RE: Motland Lot Line Realignment
 55 and 57 Banksville Road
 Section 102.03, Block 1, Lot 54 & 55

Subsequent to our initial application and appearance before the Planning Board, this office is submitting updated plans and paperwork addressing the comments expressed in both the Staff Report and Town's Consultant Engineer's review memorandum issued to the Planning Board on March 20, 2020.

MOTLAND LOT LINE ADJUSTMENT
55-57 Banksville Road
Armonk, NY 10504
SBL: 102.03-1-54, 55

WETLAND MAP
PREPARED FOR
KENT MOTLAND
SITUATE IN THE
TOWN OF NORTH CASTLE
WESTCHESTER COUNTY, NEW YORK

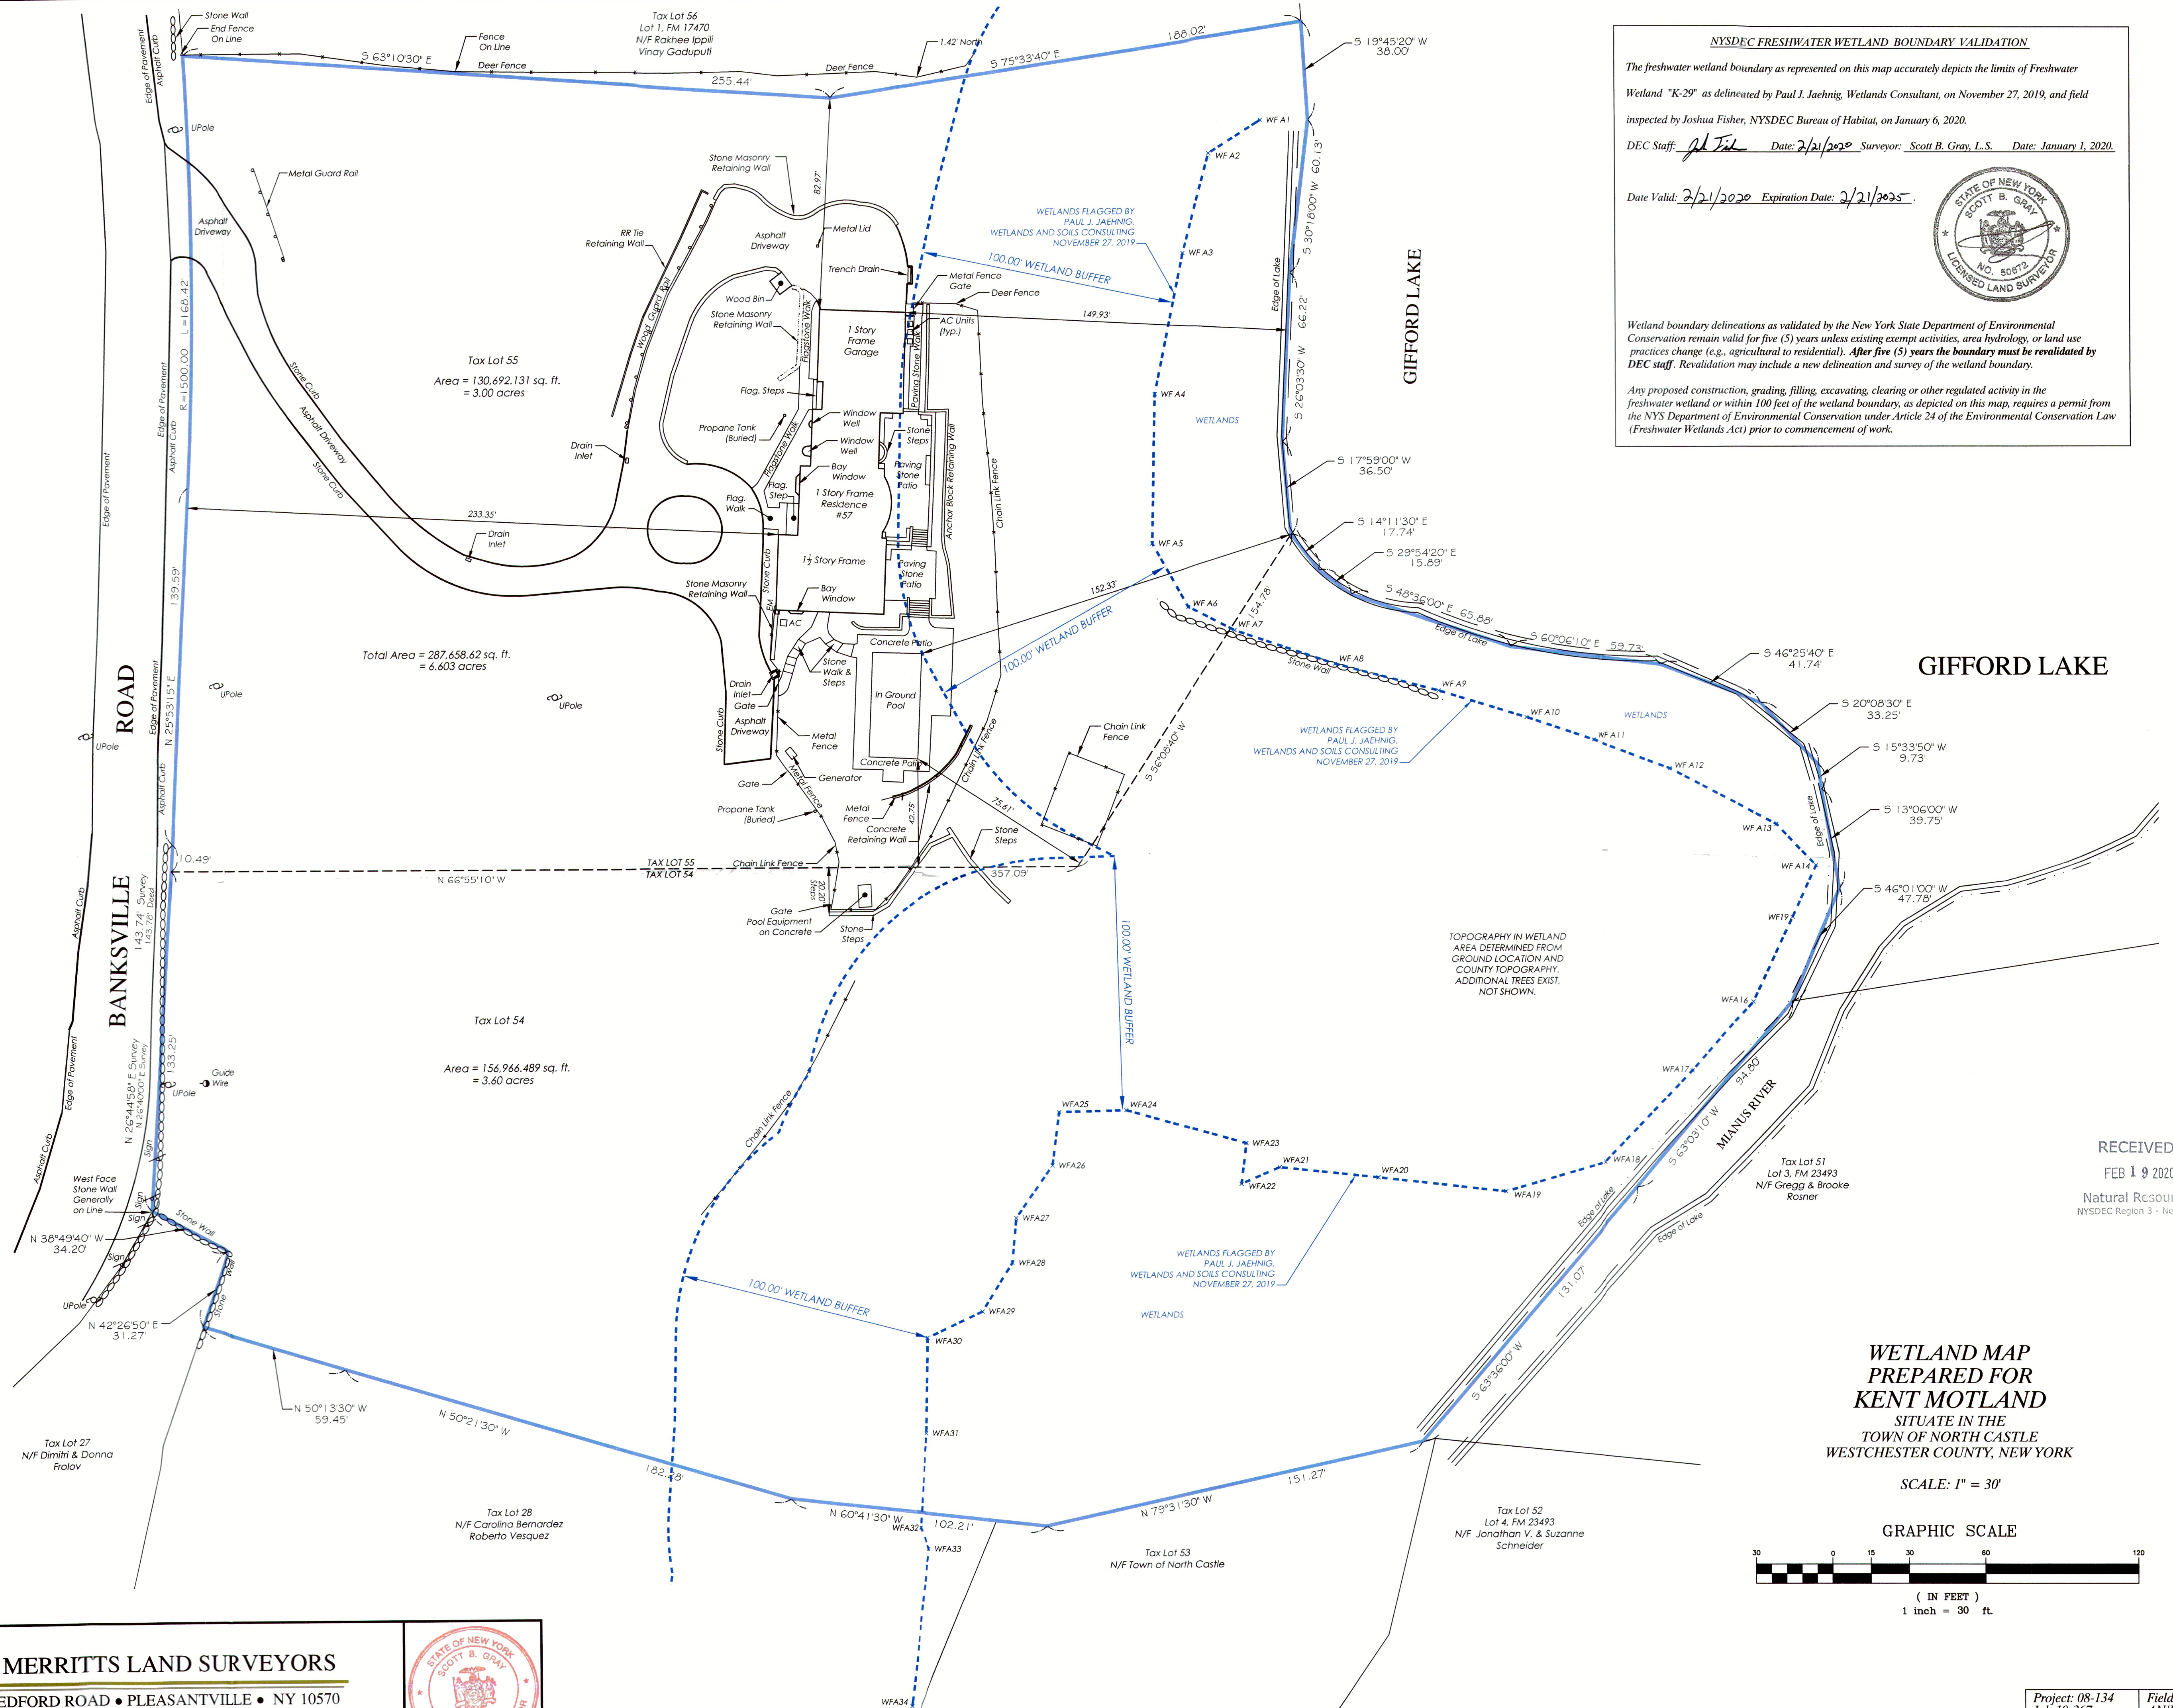
- a. *The site includes both locally and State regulated wetlands. The plan illustrates a wetland limit, but it is not clear which wetland this boundary represents. The wetland boundaries shall be established in the field with sequentially numbered flags (to be survey-located and shown on the Plat) for verification by both the Town Wetland Consultant and the New York State Department of Environmental Conservation (NYSDEC). The applicant shall provide a copy of the wetland validation by the NYSDEC and once confirmed, any adjustments to the boundary and resulting net lot area calculations shall be made. Contact this office to inspect the wetland line once the delineation has been established.*

Wetland boundary has been established in the field with sequentially numbered flags and survey located. The boundary has been indicated on the Plat. It is my understanding that the locally regulated wetland limit and the State regulated wetland line coincide with one another. The NYSDEC has observed the flagging and provided a validation of the line. A copy of the NYSDEC validation is provided for your review. A request to schedule an inspection with your office will be submitted to confirm the limit and findings by the State.
